## Diversified Metal Fabricators Service Bulletin SB 2052

<b>Title</b>	Locking Valve Leakage on Rear Railgear.
<b>Document No.</b>	SB-2052
<b>Issue Date</b>	10/08/2008 (SEW )
<b>Units Affected</b>	All rear railgear manufactured 1/2008 to 9/2008 with locking valves integral to the endcap of the rear hydraulic cylinders. (RW-1019, 1212, 1420, 1630, 1650)
<b>Purpose</b>	To address hydraulic fluid leakage from locking valves on rear cylinders.

FIG A

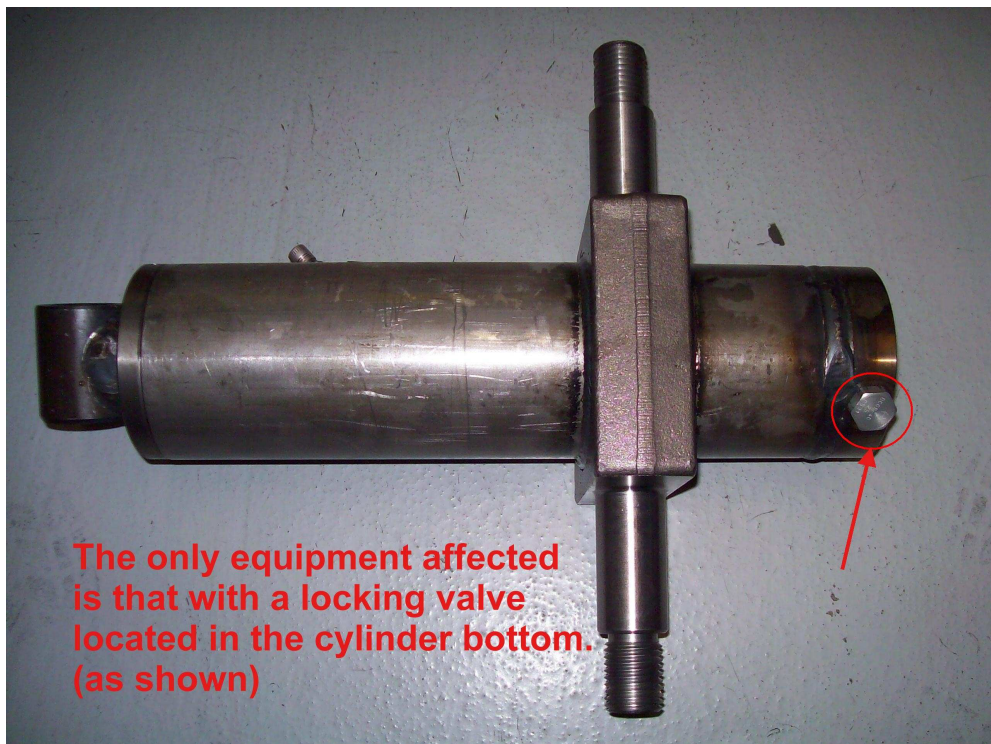
The cylinders covered under this service bulletin will have a HYDRA FORCE brand locking valve cartridge that is installed in a cavity integral to the cylinder bottom as shown in FIG A.

Manufacturing inconsistencies of the cylinder end cap with integral locking valve cavity MAY prevent the HYDRA FORCE brand cartridge from fully seating. The resulting effect is that the cylinder could either:

- A) Leak hydraulic fluid from around the cartridge or
- B) Allow the railgear to drift from rail or stowed position if mechanical locking pins are not used.

- 3) To replace the valves:
- Remove existing HYDRA FORCE locking valves
  - Inspect the cavity for any debris or other contamination.
  - Coat the new PARKER valves with hydraulic fluid paying particular attention to lubricate the seals well. (This is IMPORTANT!)
  - Start the new PARKER cartridges by hand, making as many turns as possible.
  - Tighten the cartridge to no greater than 15 FOOT POUNDS. Over torquing the valve can damage its internals and actually INCREASE likelihood of a leak.
  - Test railgear function and check for leaks.
- 4) If your railgear is covered under this service bulletin but is not currently experiencing any leakage or other problems, then please call DMF to determine if replacement is necessary.
